1. SUBMITTAL TYPE: (Is this a resubmittal? Yes ☐ No ☒)			
Deferred Submittal ☐	Addendum Number: 01	Revision Number:	CCD Number: Category A ☐ or B ☐
2. PROJECT INFORMATION:			
School District/Owner: San Beranrdo City USD		DSA File Number: 36 H7	
Project Name/School: Indian Springs HS - Health Center		DSA Application Number 04 123900

ADDENDUM NO. 1

Indian Springs High School – Health Center

DSA #04-123900 FILE #36-H7 RCA Project No. 1-78-50

NEW REFLECTED CEILING PLAN	SCALE: $1/8" = 1'-0"$	2	PARTIAL (N) RCP	SCALE: $1/8" = 1'-0"$
----------------------------	-----------------------	---	-----------------	-----------------------

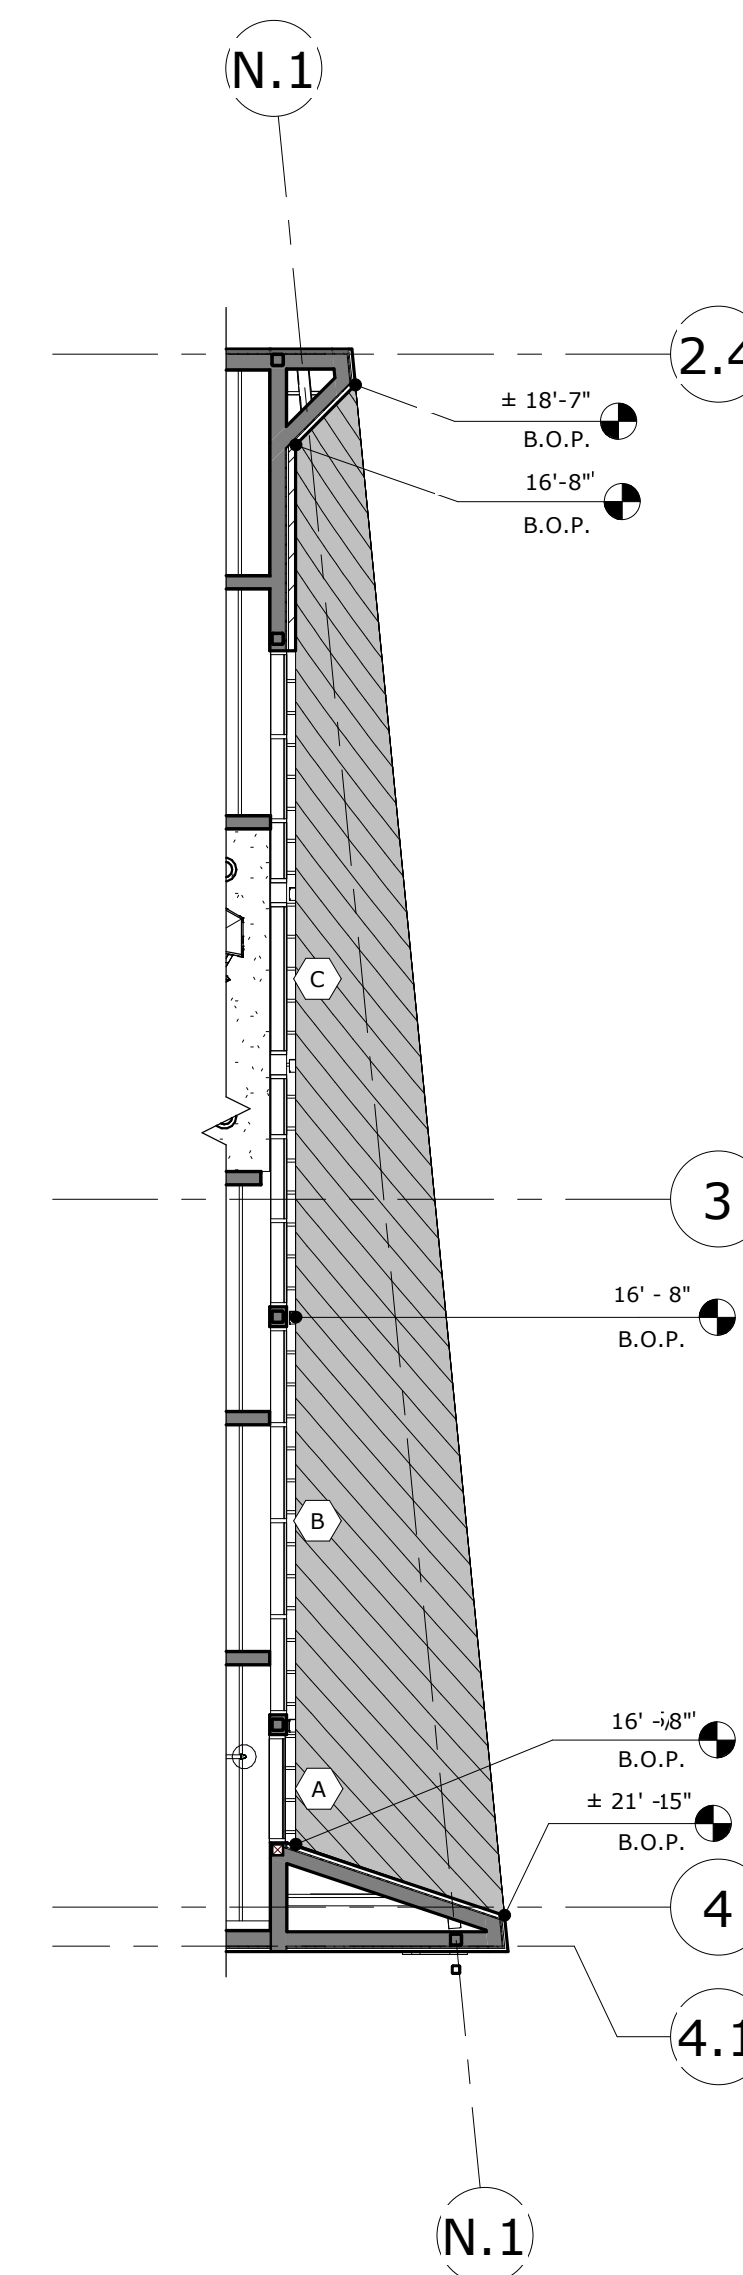
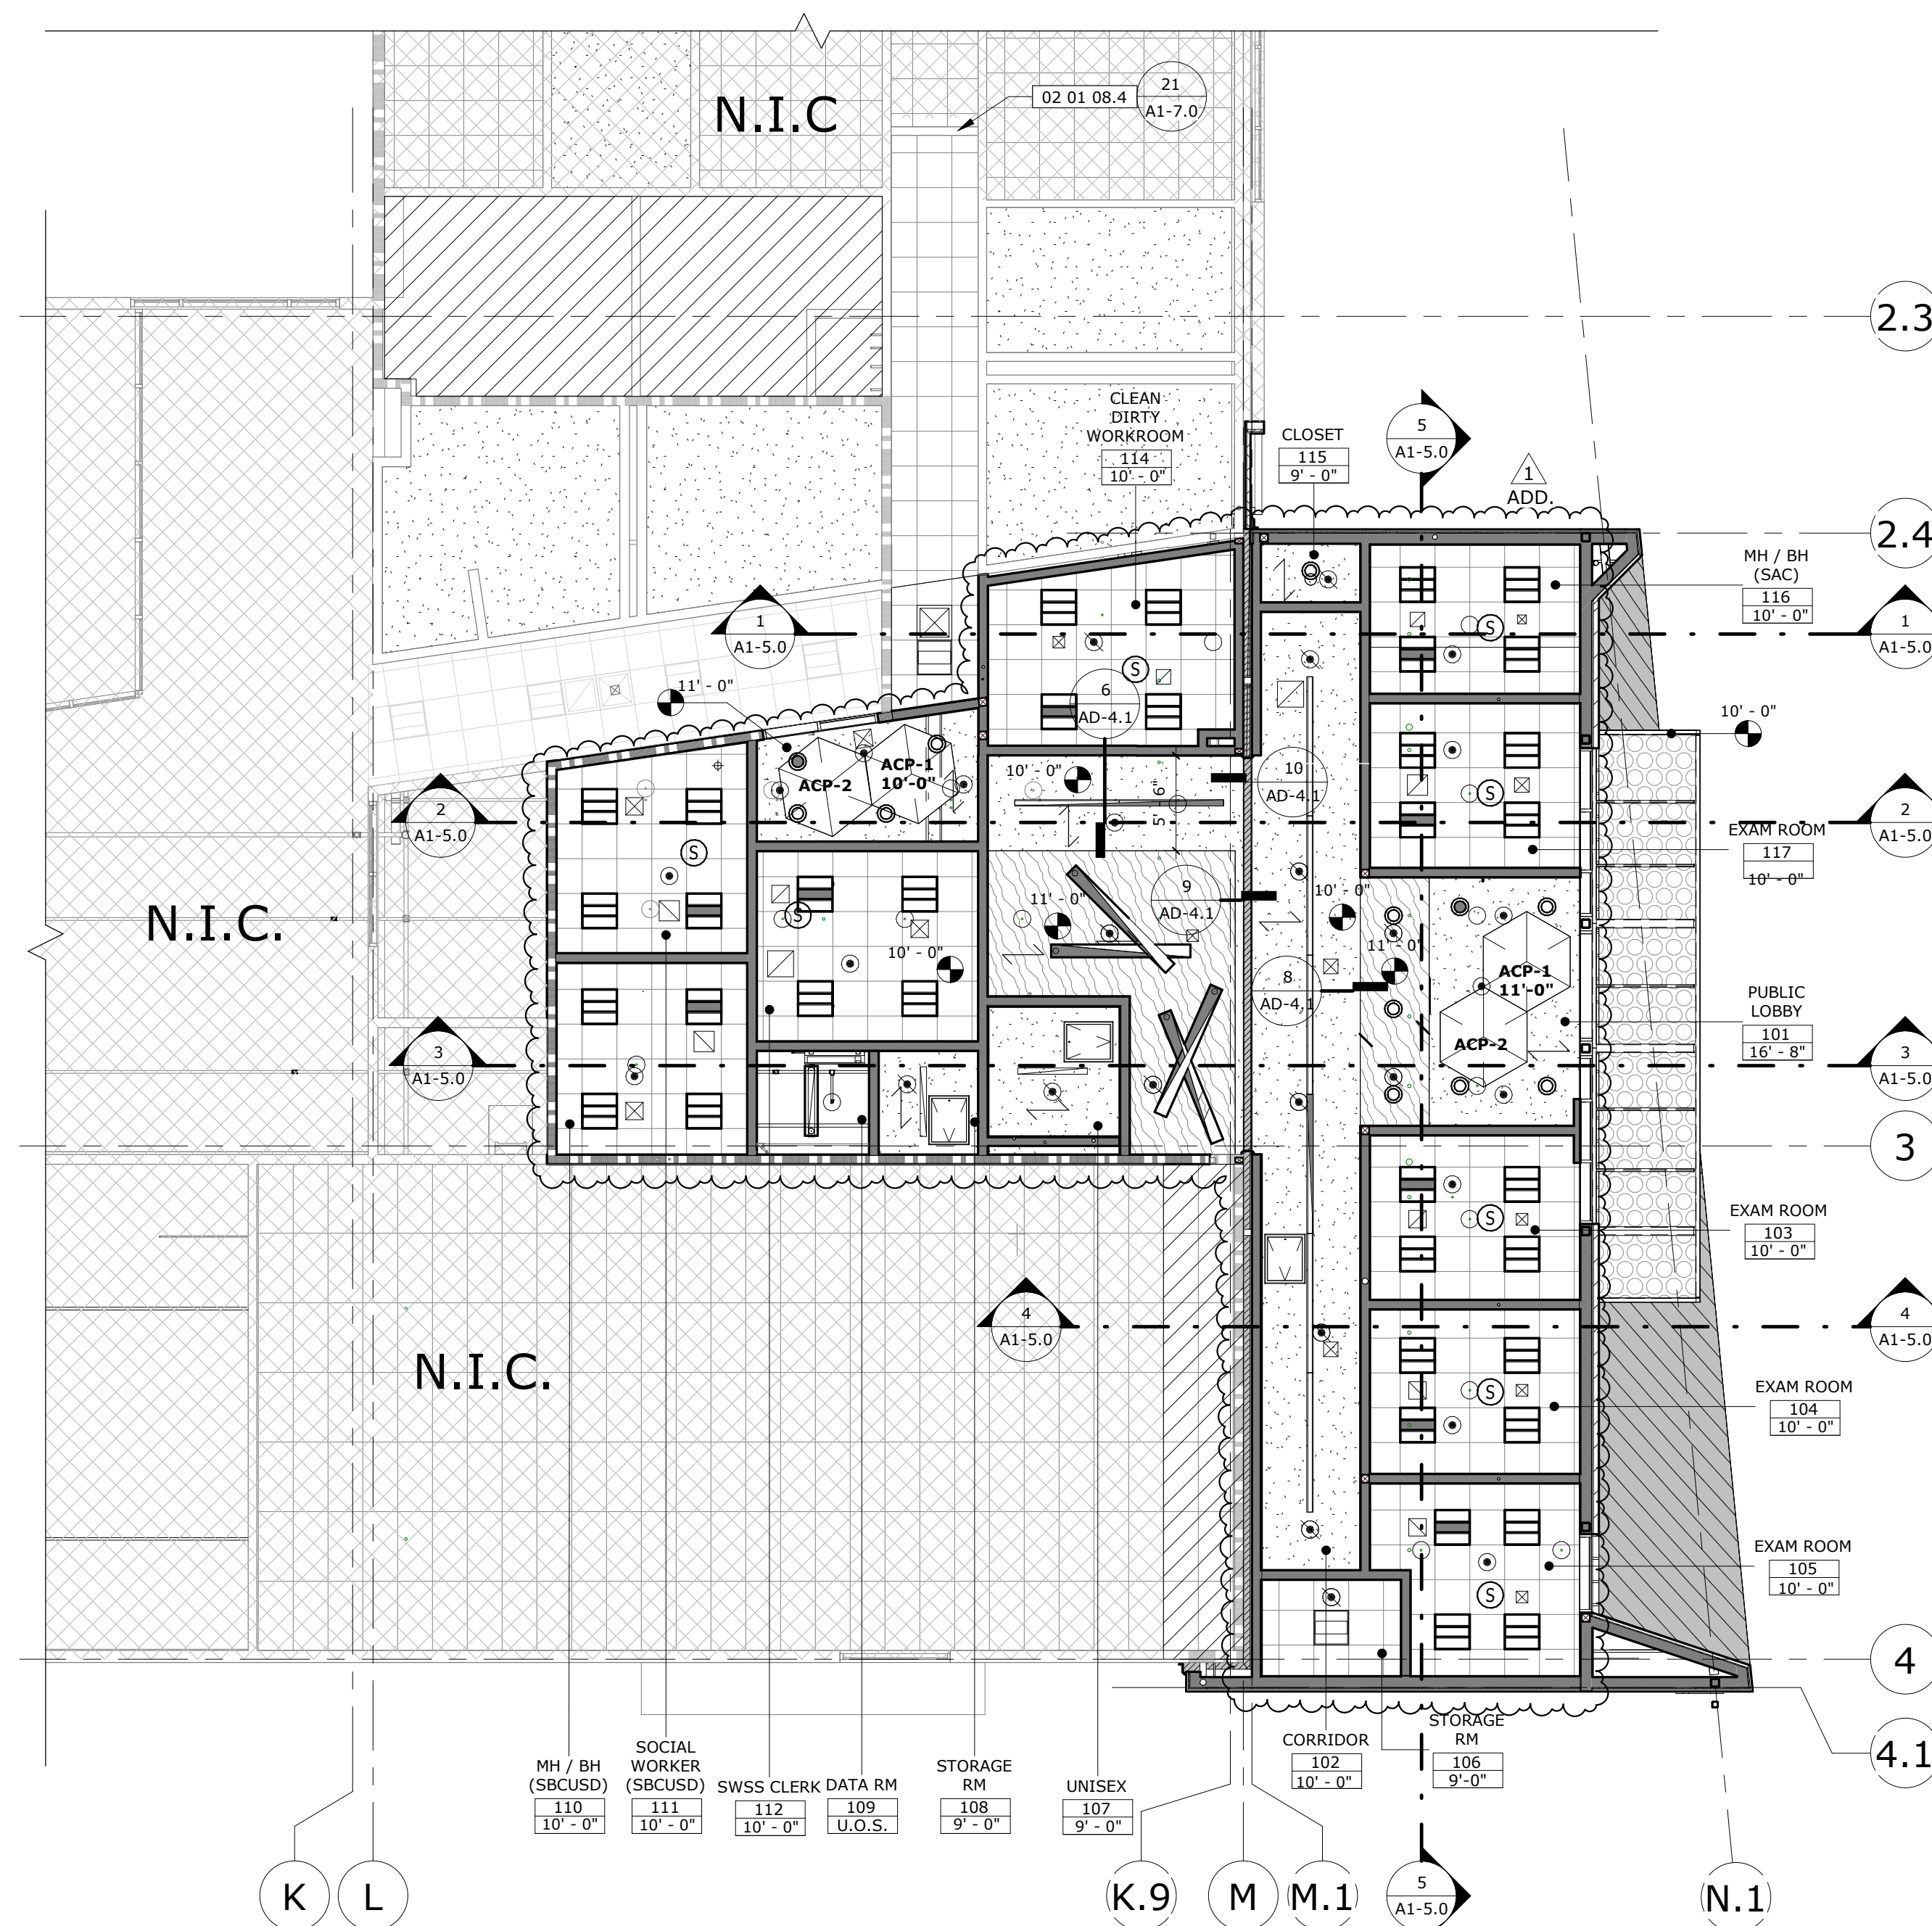
(a) Detail 2, Revised floor plan layout
- Item No. 1.11 Reference Sheet A1-3.0 – DEMO & NEW ROOF PLAN
1.11.1 Replace Sheet A1-3.0 and revise per clouded areas & items listed below:
